# COMMON PROBLEMS IN PCB DESIGN

BASED ON MINT-TEK CIRCUITS EXPERIENCE OF  
**DESIGNSPARK**

## ISSUE 2.1

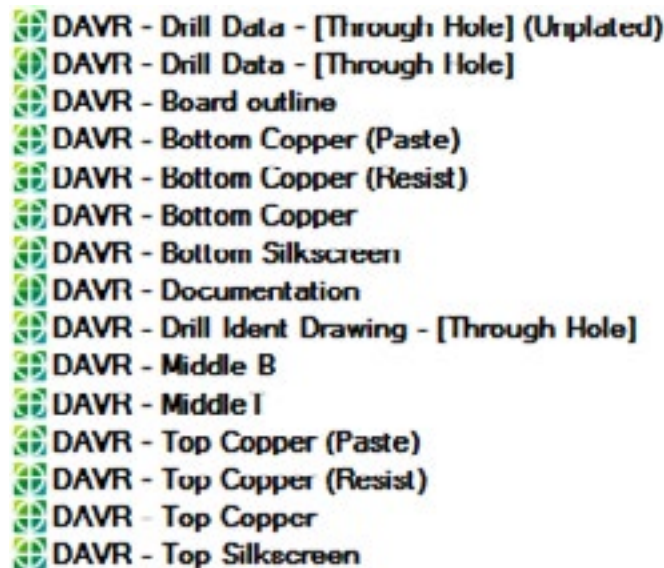
# THERE IS NO SPECIFICATION OF THE LAYER SEQUENCE.

**Result: Unnecessary delay while the manufacturer asks for clarification.**

In this example the inner layers are labelled “Middle T” and “Middle B”. The designer may think this makes total sense - that “Middle T” would go next to the top layer and “Middle B” next to the bottom. Manufacturers don’t assume unless they are familiar with your work and have previously seen the same layer configuration.

More than likely they will place the order on hold and query it.

## ISSUE 2.2

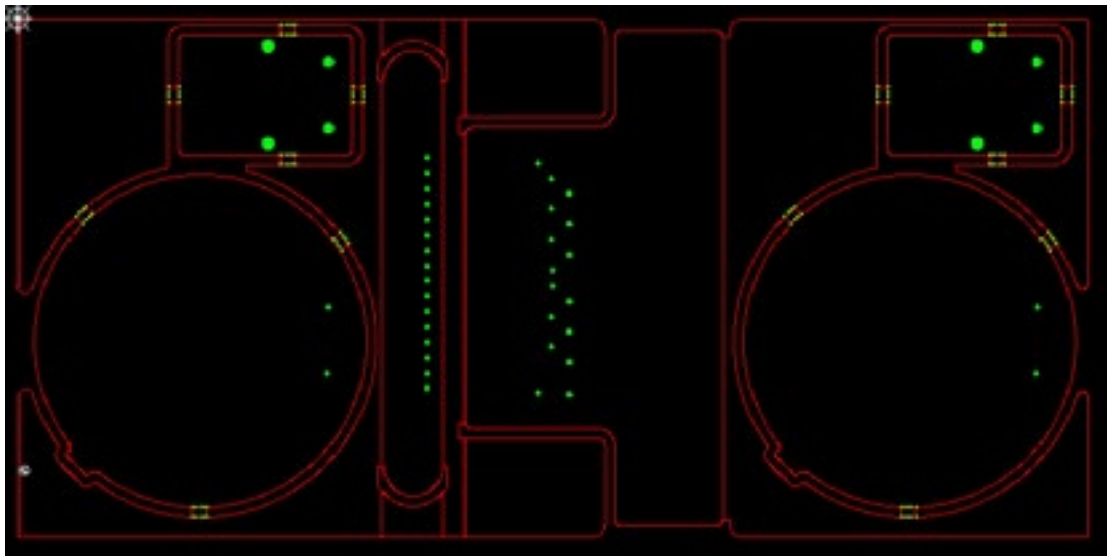
# MANUFACTURER DOESN'T RECOGNISE OR UNDERSTAND THE FUNCTION OF A FILE.

**Result: Unnecessary delay while the manufacturer asks for clarification.**

In this case, the designer has sent extra information with no clarification on its purpose. Again, the manufacturer will seldom make assumptions and will have to get more information.

fig. 1

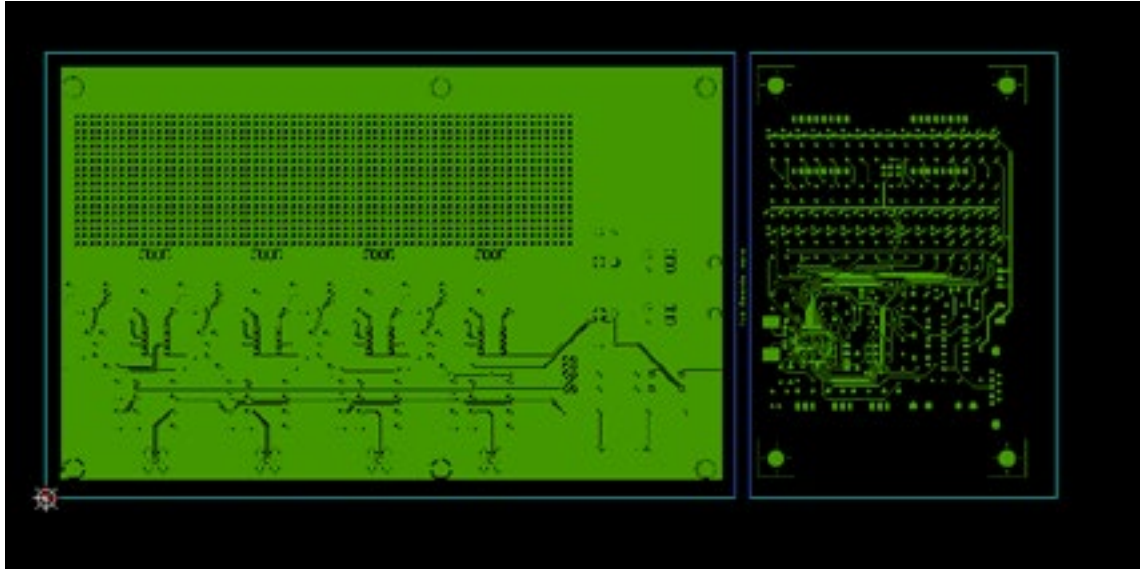
The customer has supplied a board outline layer which clearly details the outlines for two separate boards. On the top layer of the smaller board you can see that there are what appear like corner markers left inside the board. *fig. 1*

This conflicts with the outline in the contour layer, shown in **fig. 2**. The PCB manufacturer will not make any assumptions here and will delay approval for production until it is cleared up. Layout Engineers should remove any ambiguous notations from the outline or add a note with an explanation and instructions for how to deal with them.

#### ISSUE 3.2

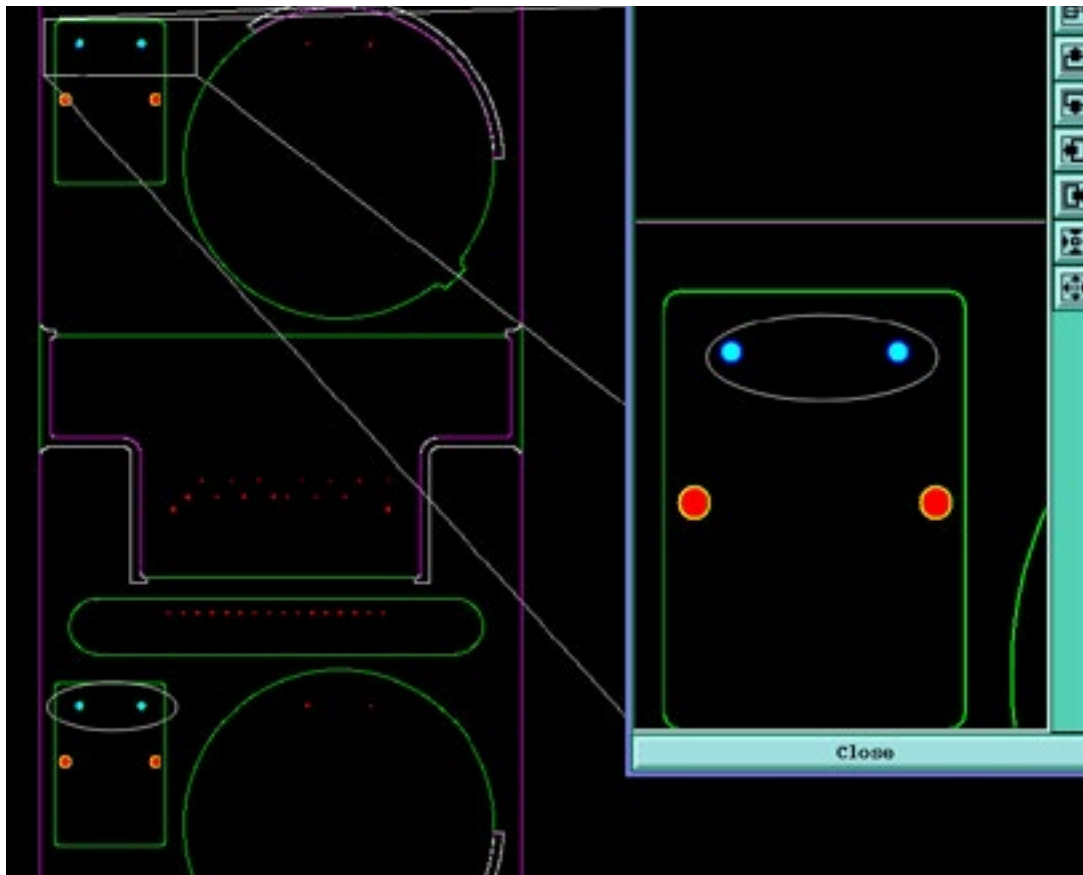
### CIRCUIT PADS IN OUTLINE HAVE NO CORRESPONDING INFORMATION ON OTHER LAYERS.

A very common problem occurs when the data has hole outlines or pads in the board outline layer. This suggests to the manufacturer that these holes are required to be non-plated.

But when he compares these locations to the copper layers, it can be seen that these locations have pads and tracks going to them which suggests that these holes require plating. So again the order goes on hold and valuable time is lost. It is important for the designer to double check holes and tracks in the outline and make sure they have corresponding information in the other layers. Notes for the manufacturer are very useful to help alleviate misunderstandings.

### ISSUE 3.3

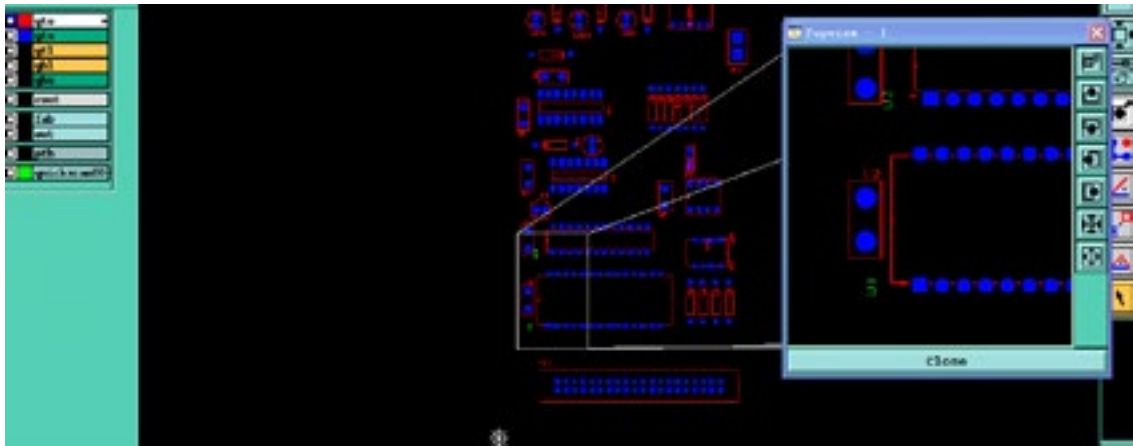
## CONFIRM SILKSCREEN CHARACTERS.

In this example, the customer requested to have top silkscreen on the boards. An extra layer was added that, when viewed, looked like it should be added to the silkscreen layer. Without any instructions the manufacturer had no choice but to hold production and clarify.

## NON-PLATED HOLES TOO CLOSE TO THE TRACK.

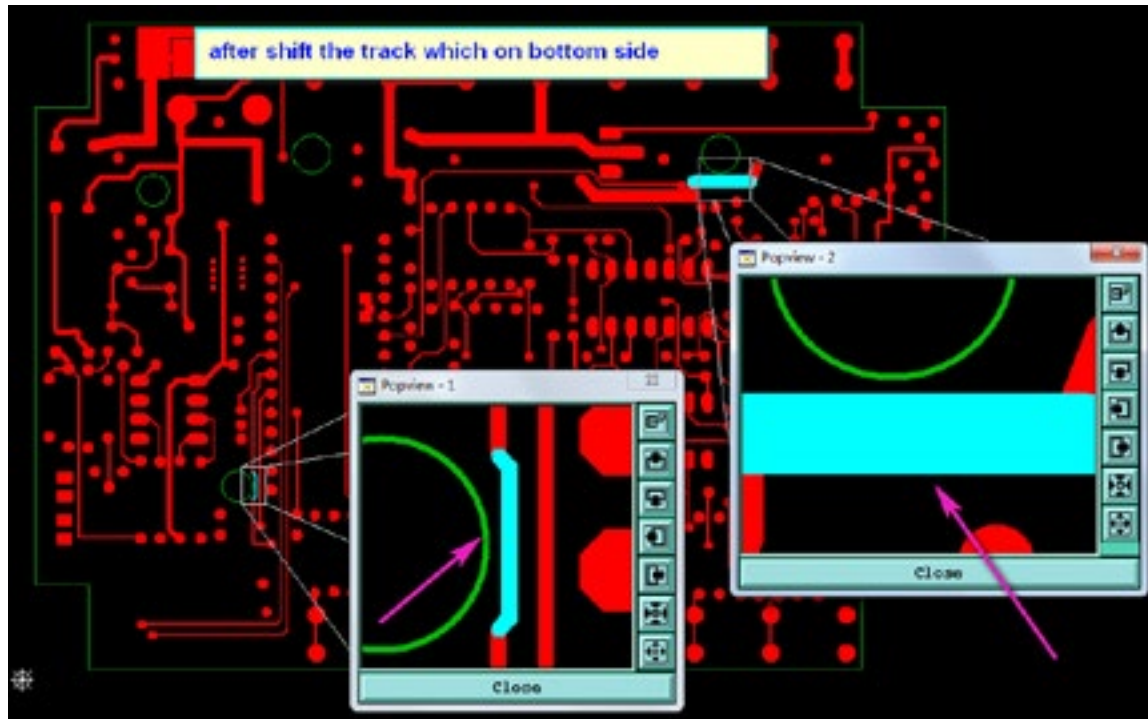
**Result: Unnecessary delay while the manufacturer asks for changes.**

When designing a PCB, it is important to be familiar with all the manufacturer's minimum criteria. In this example, the PCB designer adhered to all the familiar manufacturing specifications but ignored the minimum gap requirement between tracks and non-plated drills. If no such spec is available, a good approximation is achieved by adding the minimum annular ring requirement for a component hole and the minimum pad to track spacing, and keeping a minimum of that distance between non-plated drills and cut-outs and the nearest tracks.

#### ISSUE 4.1

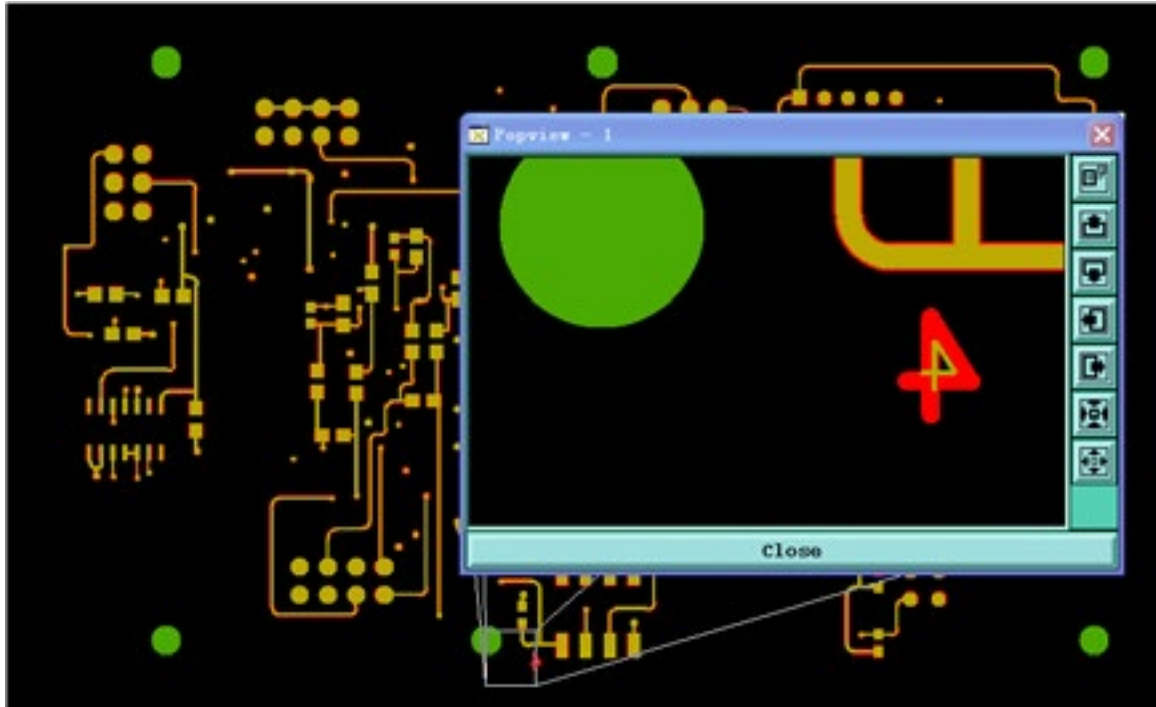
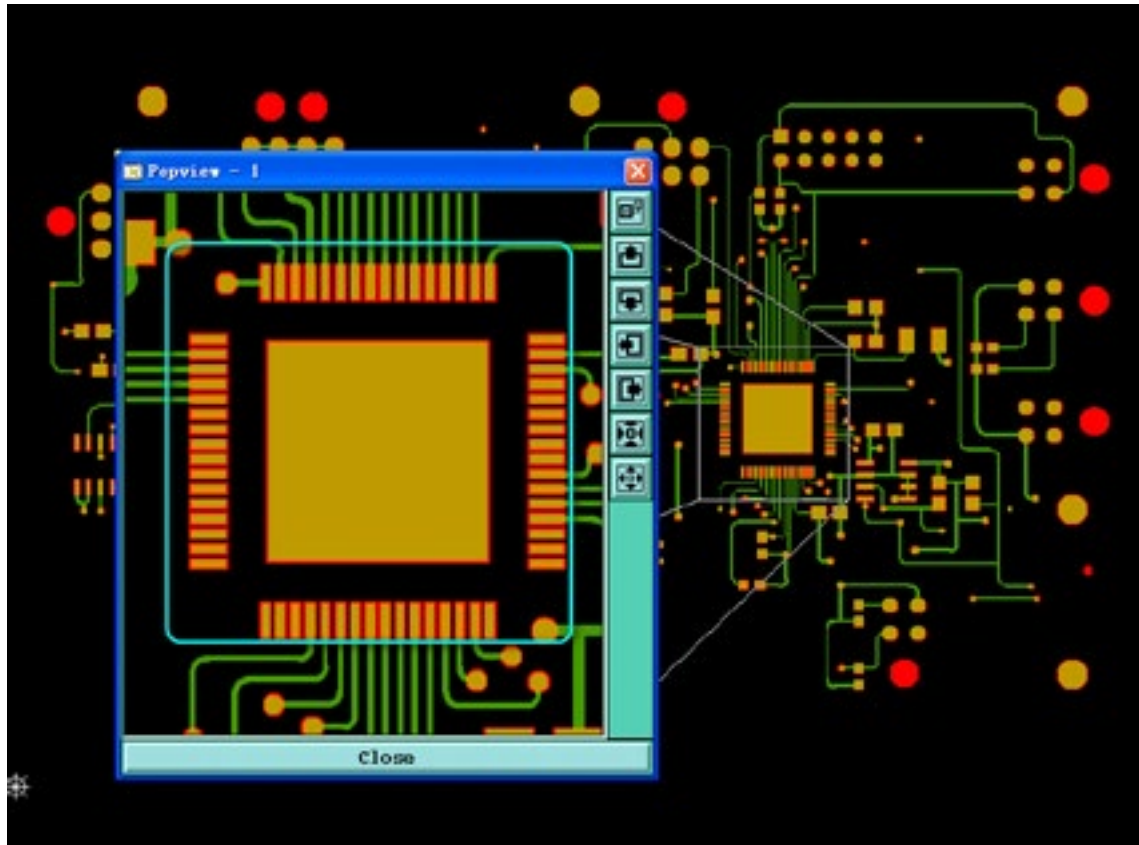
### ETCH CHARACTERS TOO SMALL.

**Result: Potential unnecessary delay while the manufacturer asks for clarification. Unsightly, PCB design.**

Check what is the smallest possible text size that can be manufactured. Electrically the function of the PCB won't be affected. Text that is too small cannot be clearly read and doesn't properly represent the work you put into your design. It may also result in delays while the manufacturer clarifies.
